## **ADDENDUM 01**

### **EAST PIER DEEP WATER WHARF FOR USM/NOAA**

Project #: 0297.23.001

Project Name: East Pier Deep Water Wharf for USM/NOAA  
30<sup>th</sup> Avenue  
Gulfport, MS 39501

**C204**

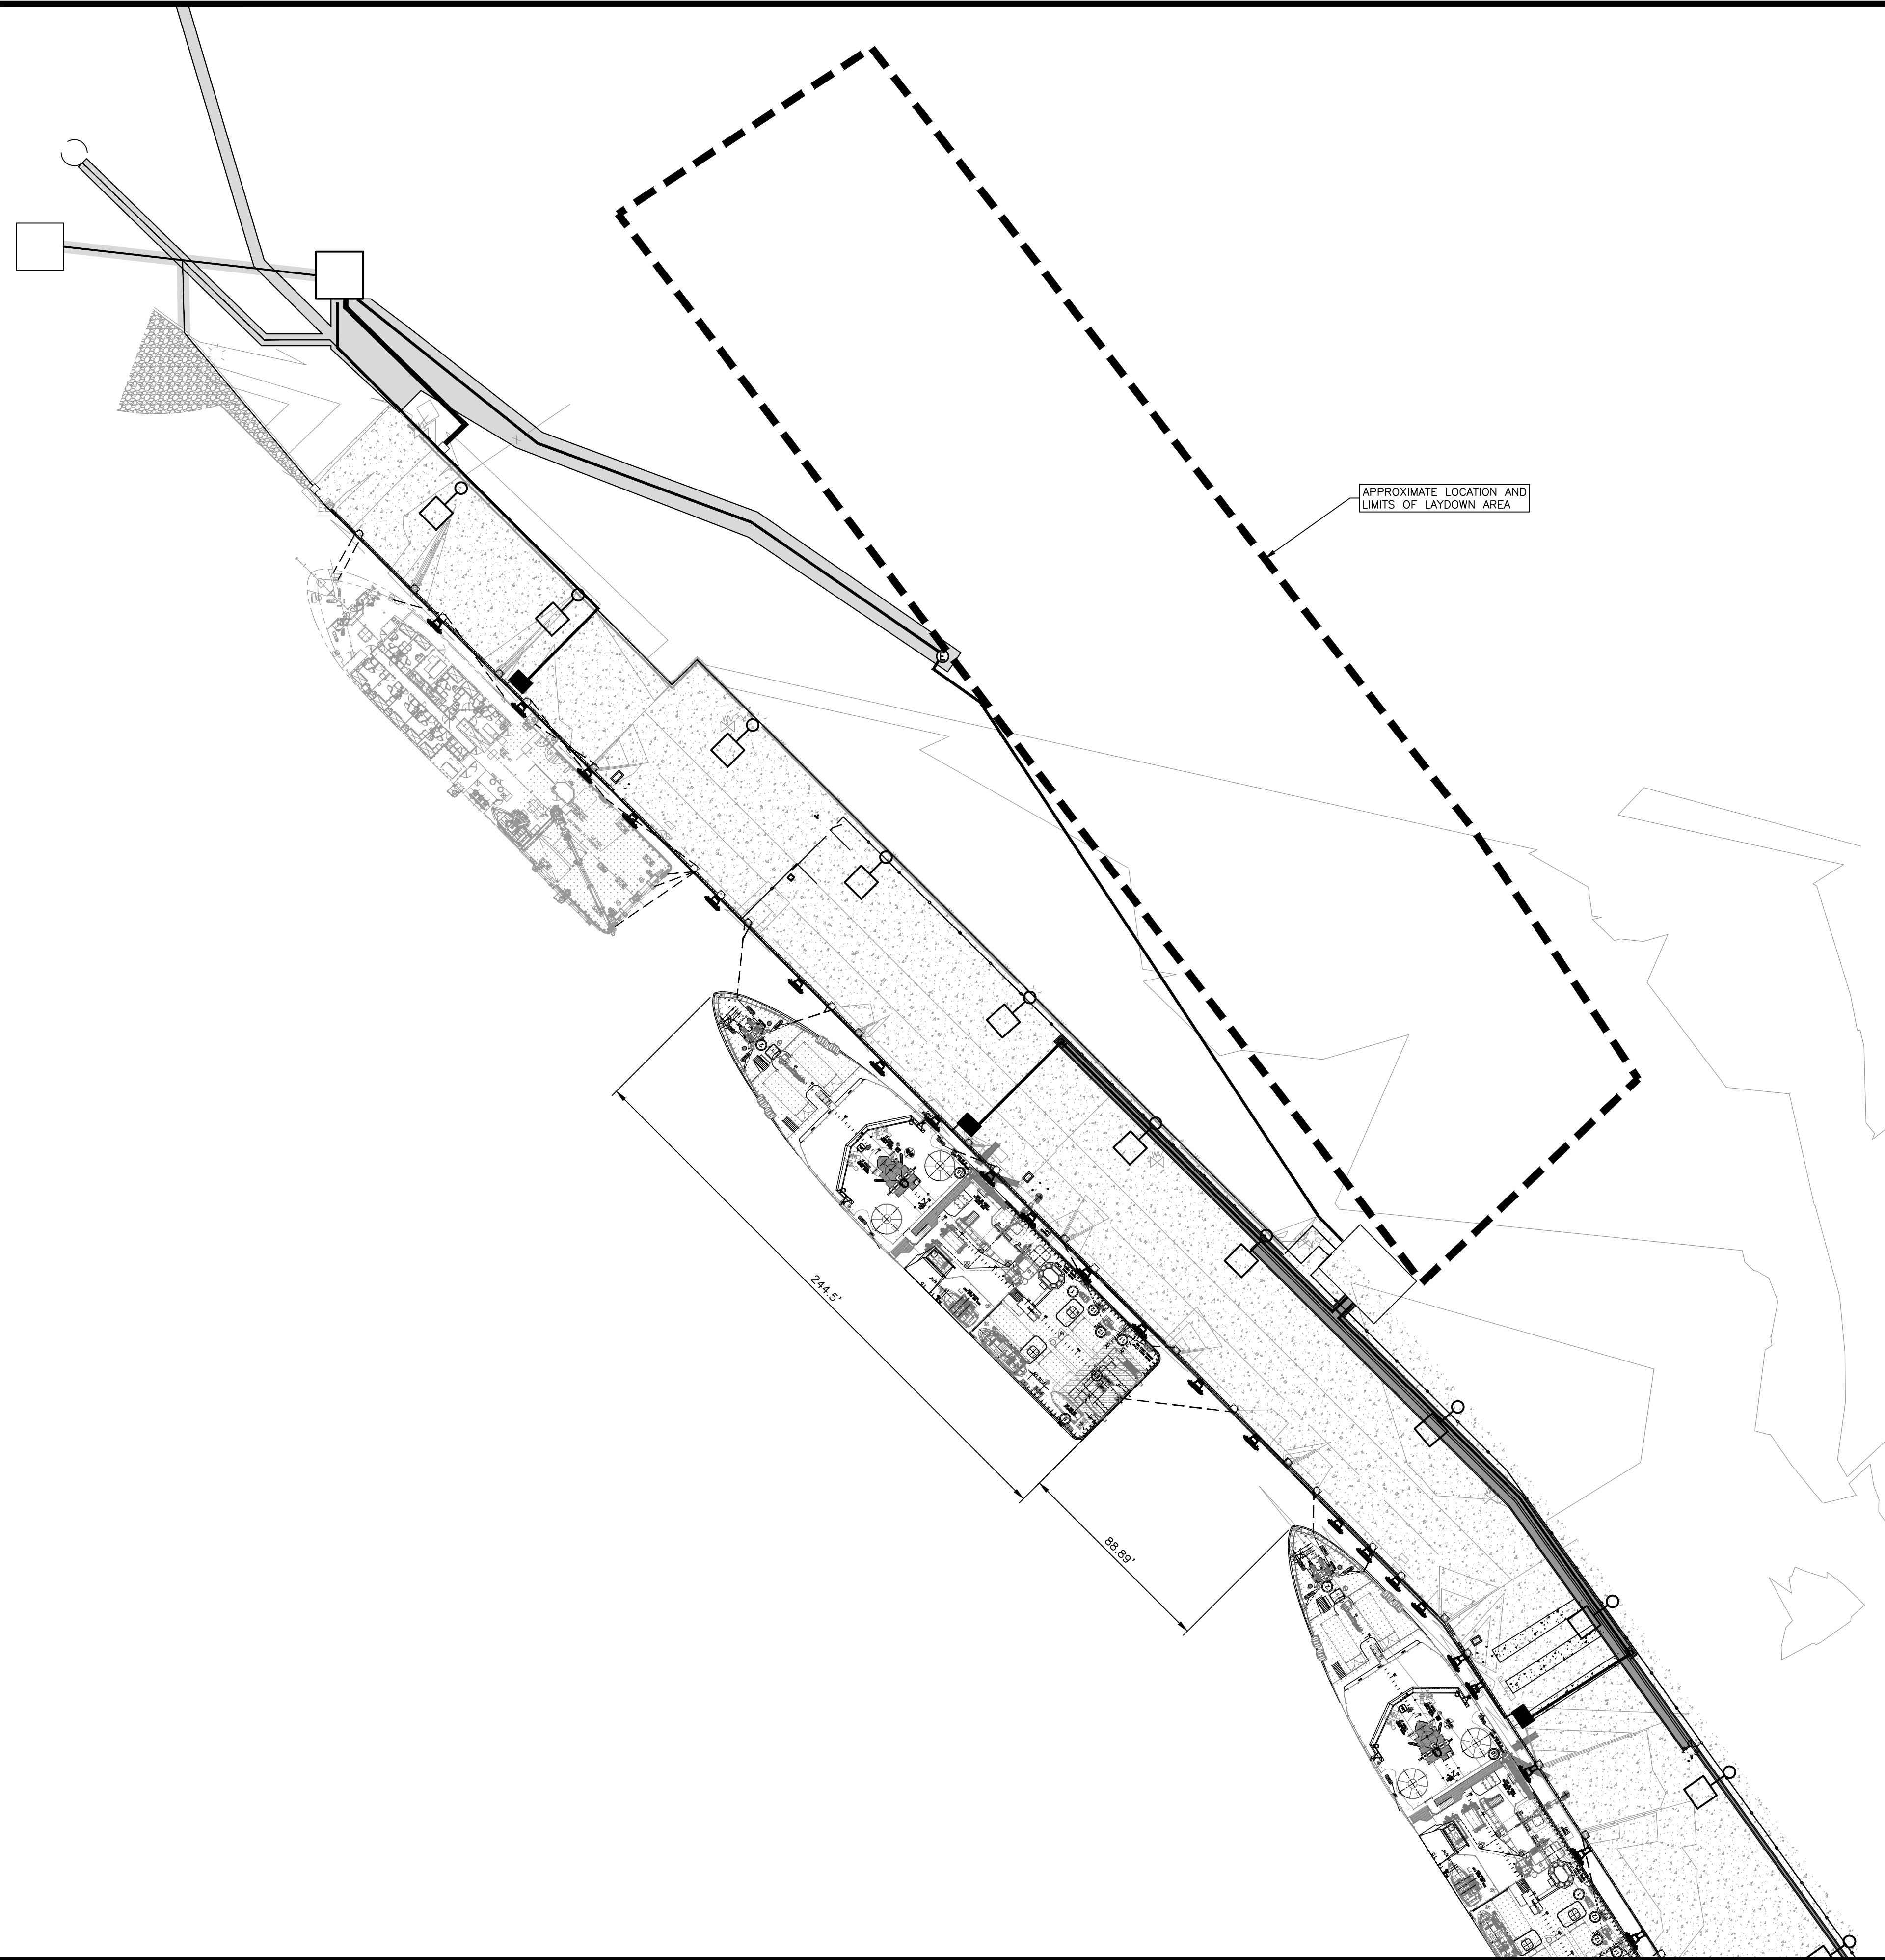
- B1. Where will construction laydown area be located? **See Sheet C204 and C206 for laydown areas.**
- B2. Is it a possibility to delay the issuance of the notice to proceed to account for the long lead times of some of the products? **It is not an option to delay the issuance of the notice to proceed. The contract times for each milestone have been revised to account for the product lead times. Refer to Part D of this addendum.**

- C1. Civil Sheets:
1. Replace Sheet C204 in its entirety.
  2. Added Sheet C206 to show laydown area for the East Pier.
- C2. Structural Sheets:
1. SD100 Note:
    - Remove Type 1 MV Fenders in their entirety, anchor plates to remain if approved by fender manufacturer (12 total field verify) – Alternate 3.
  2. S102 Note:
    - 3/8" 304 Stainless Steel slip resistant floor plate, shall be revised to "3/8" steel resistant floor plate."
  3. Replace Sheet S100 in its entirety.
- C3. Plumbing Sheets:
1. P001: Plumbing Note I:
    - All new ductile iron pipe shall be painted with a rust preventative alkyd primer and two alkyd enamel topcoats, pressure sewer shall be painted green. Water shall be painted blue to match existing.
